# Access Compliance Report

## Public Rights-of-Way

### (Curb Ramps)

Intersection ID: 10024336	Main Street: CREEKRIDGE_RD	Cross Street: N/A	Location: S
ADA ID: E8D29556DBC8	Ramp Type: PerpDiag	Initial Pass/Fail: Fail	Overall Compliance: No
		Severity Score: 12.5

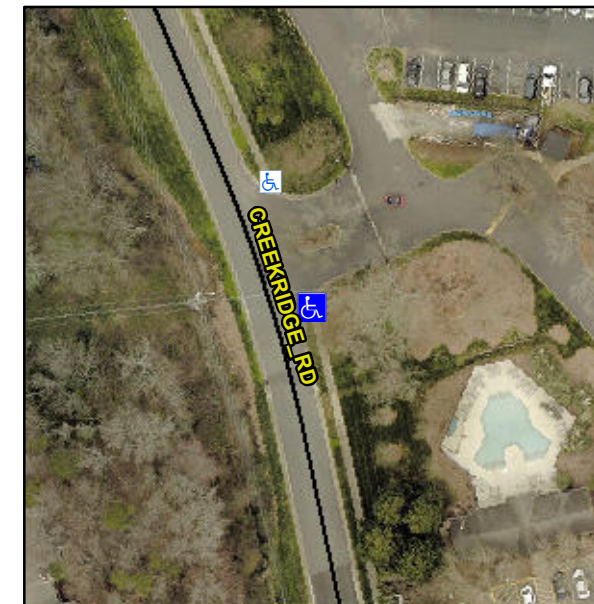
Compliance	Description	Data	Compliance	Description	Data
N/A	Ramp Length (in)	36.0	No	Ramp Slope (%)	11.0
Yes	Ramp Width (in)	48.0	Yes	Ramp XSlope (%)	0.5
N/A	Flare Type LT	N/A	N/A	Flare Type RT	N/A
N/A	Flare Slope LT (%)	N/A	N/A	Flare Slope RT (%)	N/A
N/A	Flare Traversable LT?	N/A	N/A	Flare Traversable RT?	N/A
N/A	Landing Length (in)	N/A	N/A	DWS Provided?	N/A
N/A	Landing Width (in)	N/A	N/A	DWS Contrast?	N/A
N/A	Landing Slope (%)	N/A	N/A	DWS Length (in)	N/A
N/A	Landing X Slope (%)	N/A	N/A	DWS Full Width?	N/A
N/A	Landing Curb? (Y/N)	N/A	N/A	DWS Offset (in)	N/A
N/A	Shared Landing?	N/A			
N/A	Gutter Ponding?	N/A	N/A	Gutter Slope (%)	N/A
N/A	Gutter Lip Ht (in)	N/A	N/A	Gutter X Slope (%)	N/A
N/A	Painted X Walk1?	No	N/A	Painted X Walk2?	No
	X Walk 1 Direction	To N		X Walk 2 Direction	To W
N/A	X Walk 1 Width (in)	N/A	N/A	X Walk 2 Width (in)	N/A
	X Walk 1 Slope (%)	2.1		X Walk 2 Slope (%)	1.4
	X Walk 1 X Slope (%)	6.0		X Walk 2 X Slope (%)	2.3

**Remove & Replace Curb Ramp With Two New Directional Ramps or Equivalent.**

**R304.2.2**
